Accessibility Design Review – DA

Project Title: **Hunternview Village**
 Corner Bridgman Road & Glass Parade, Hunternview

Job Number: **4271**

Report Version: **ADR4271v1.1**

Figure 1 – Proposed Site Plan

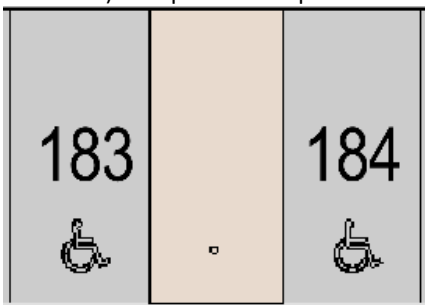
DWG No	Comment/Issue(s)	Recommendation(s)	Compliance Achieved
DA0.02, DA1.02	<ul style="list-style-type: none"> Accessible carparking bays A total of 204 carparking bays are proposed A minimum of 1 accessible space for every 50 car parking spaces (or part thereof) is required to be provided 	<ul style="list-style-type: none"> 6 accessible carparking spaces are proposed within the on grade carparking area, a minimum of 5 accessible Carparking spaces are required by Clause D3.5 of the BCA. Recommend that accessible carparking spaces be provided as close as possible to the entry points. Accessible parking requires complying with BCA D3.5 and AS 2890.6-2009. Minimum dimension 2.4m + 2.4m shared zone width. Further review at detail design stage. 	Yes, Further review at detail design stage
DA0.02, DA1.02	<ul style="list-style-type: none"> Surfaces 	<ul style="list-style-type: none"> Accessible car parking bay surfaces to comprise a firm plane surface with fall not exceeding 1:40 in any direction. A fall of 1:33 is acceptable if surface is bituminous seal and parking space is outdoors. 	Note

DWG No	Comment/Issue(s)	Recommendation(s)	Compliance Achieved
DA0.02, DA1.02	<ul style="list-style-type: none"> The pathways to the supermarket entrances indicate to be of appropriate gradient, widths and circulation 	<ul style="list-style-type: none"> As the design progresses tactile indicators and different color and textural contrasts on the pathways will be highlighted 	Yes, Further review at detail design stage
DA0.02, DA1.02	<ul style="list-style-type: none"> Walkway clearance spaces 	<ul style="list-style-type: none"> External fixtures to be set back 500mm from the walkway. Walkway to be a minimum of 1000mm clear width (1200mm preferred). 	Yes
DA0.02, DA1.02	<ul style="list-style-type: none"> Walkway surfaces 	<ul style="list-style-type: none"> Slip resistant surfaces required on all walkways. Ground surfaces abutting walkways to follow grade of walkway for 600mm or provide 450mm kerb or handrail/kerb rail combination. Changes in surface shall have abutment vertical rises of 3mm or less; or 5mm or less where rounded edges are provided. 	Note

DA0.02, DA1.02	<ul style="list-style-type: none"> Kerb ramps 	<ul style="list-style-type: none"> Ensure kerb ramps comply with AS 1428.1-2009. Further assessment and review will be carried out at detail design phase. 	Further review at detail design stage
-------------------	--	---	---------------------------------------
